FLYING HORSE NORTH FILING NO. 5  
CONSTRUCTION DOCUMENTS

AS-BUILT VERSION 1.0, DATED 7/22/2026

COVER & LEGEND  
COVER

SHEET  
CV

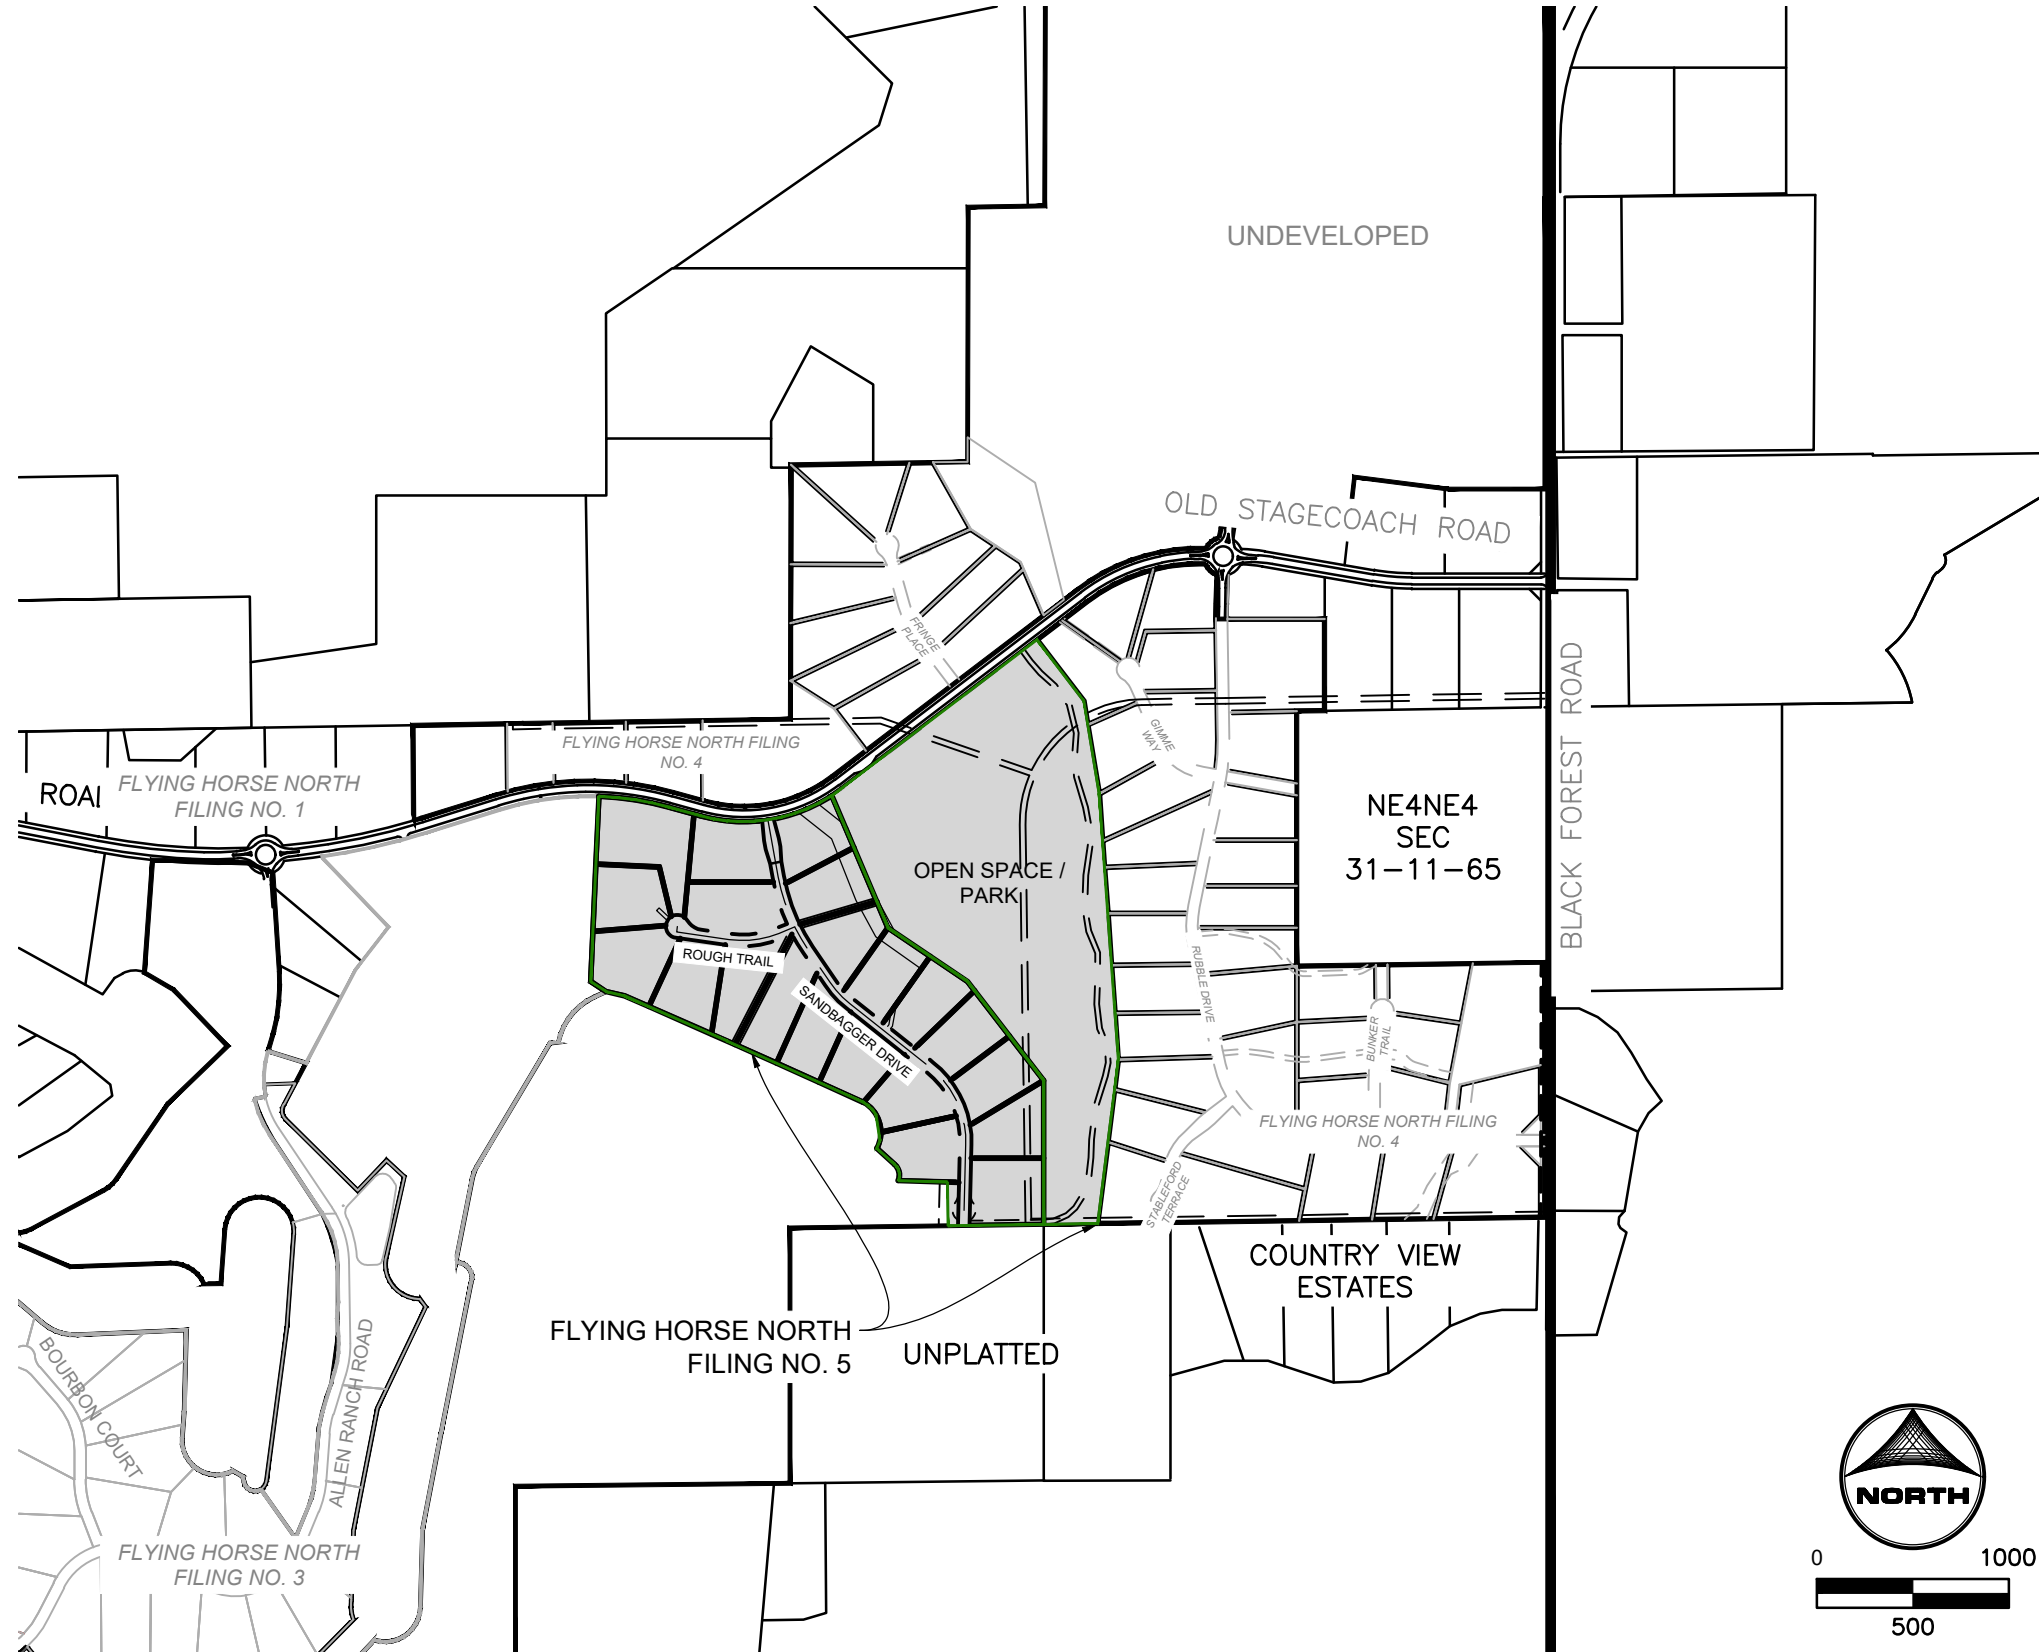
New stamp required on each sheet, not only the cover sheet.

**SHEET**  
**ST**  
**6**

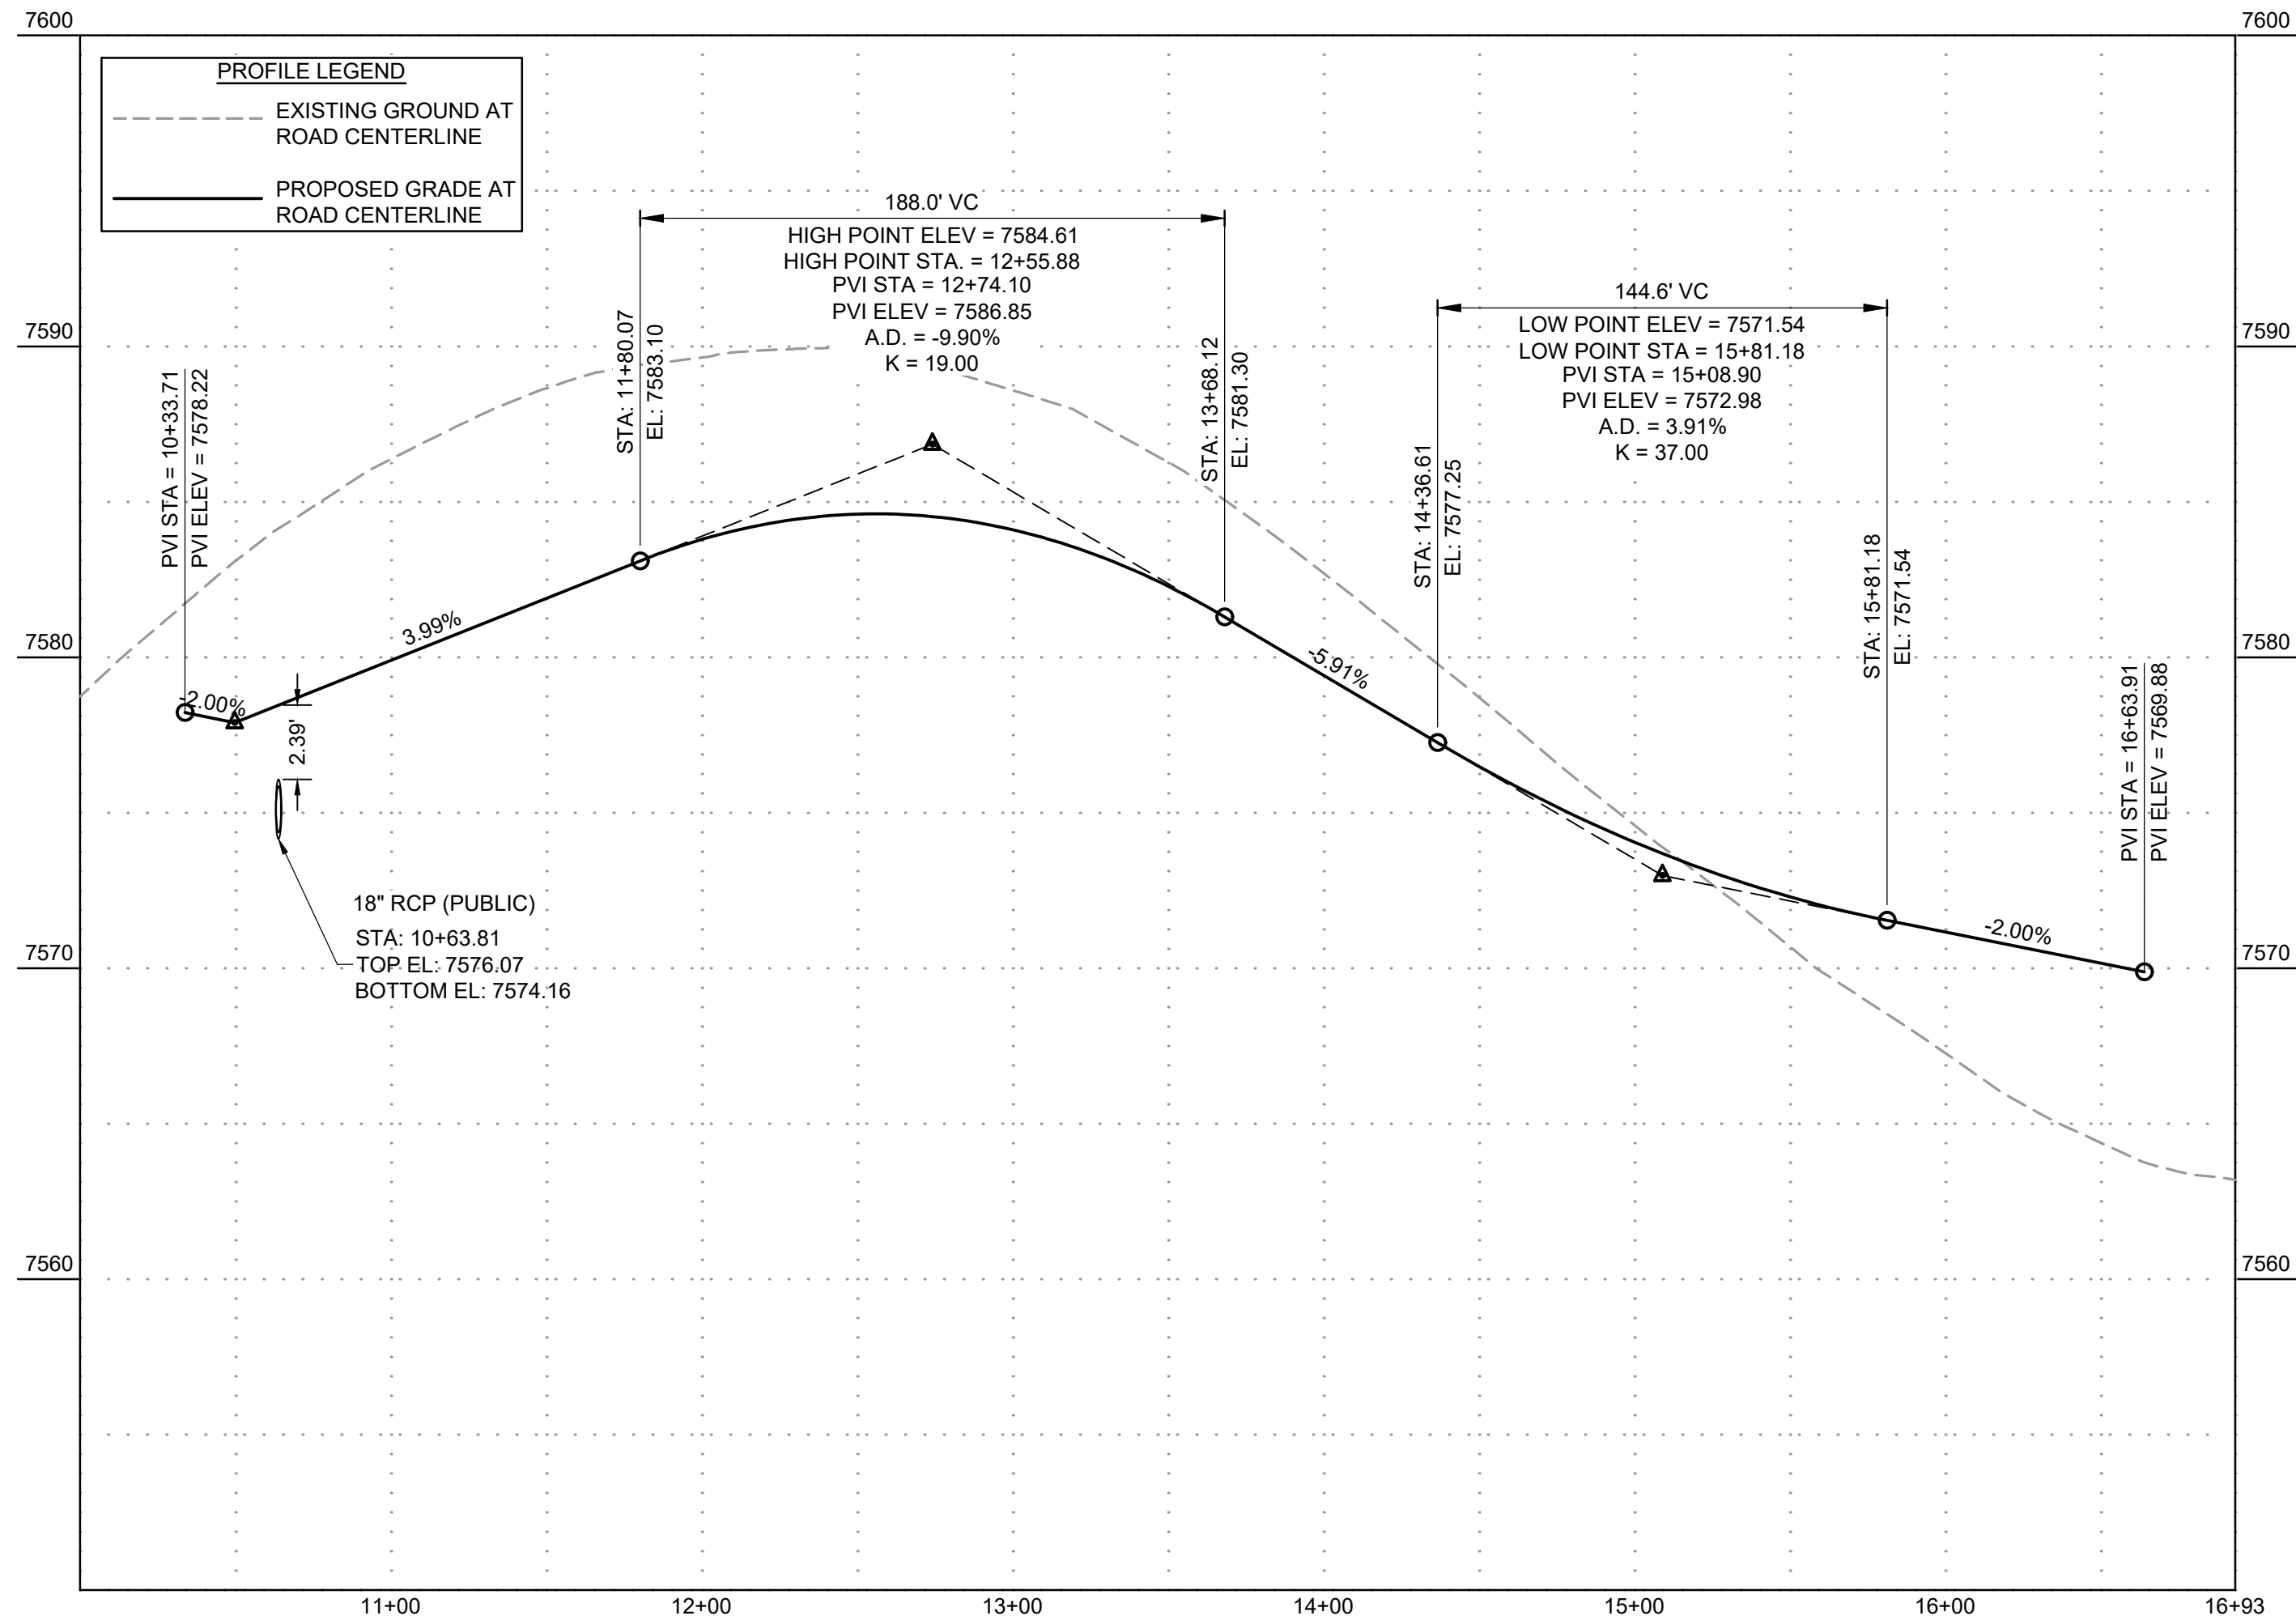
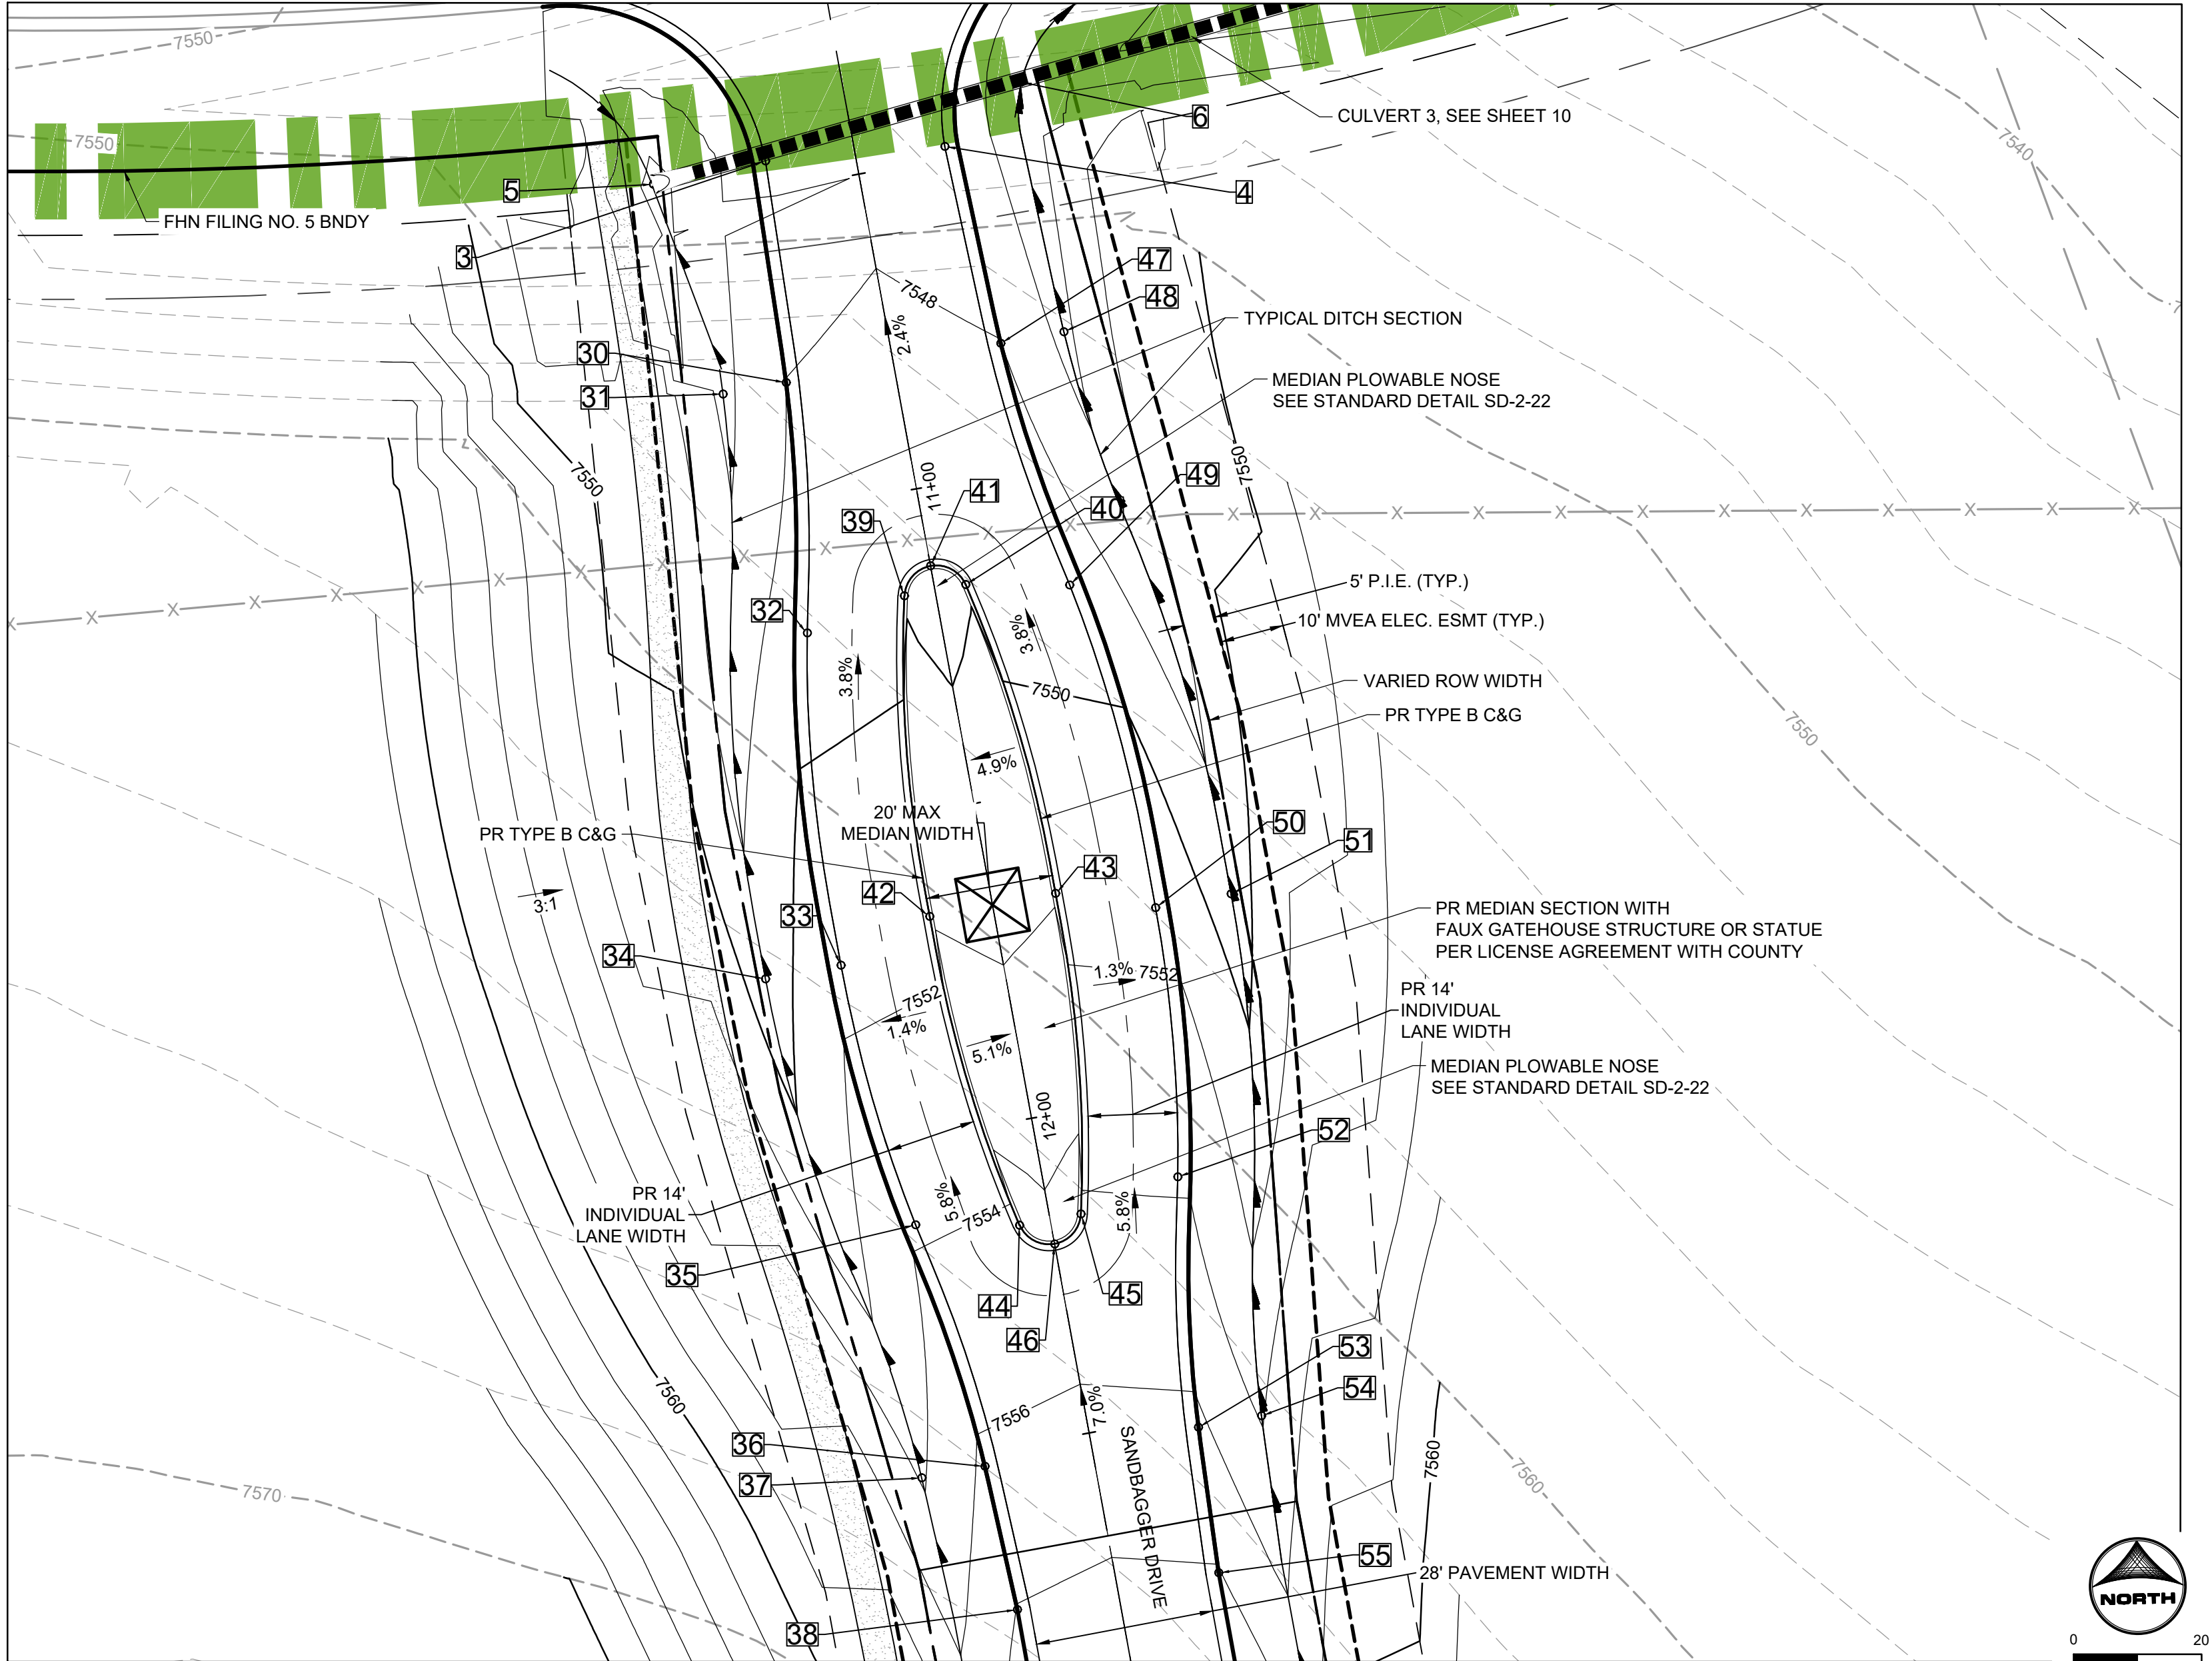
| POINT TABLE |          |                  |              |          |         |
|-------------|----------|------------------|--------------|----------|---------|
| 28          | PCR      | ROUGH TRAIL      | STA ???      | ??? ??   | 7569.89 |
| 29          | LOW PT   | ROUGH TRAIL      | STA ???      | ??? ??   | 7566.07 |
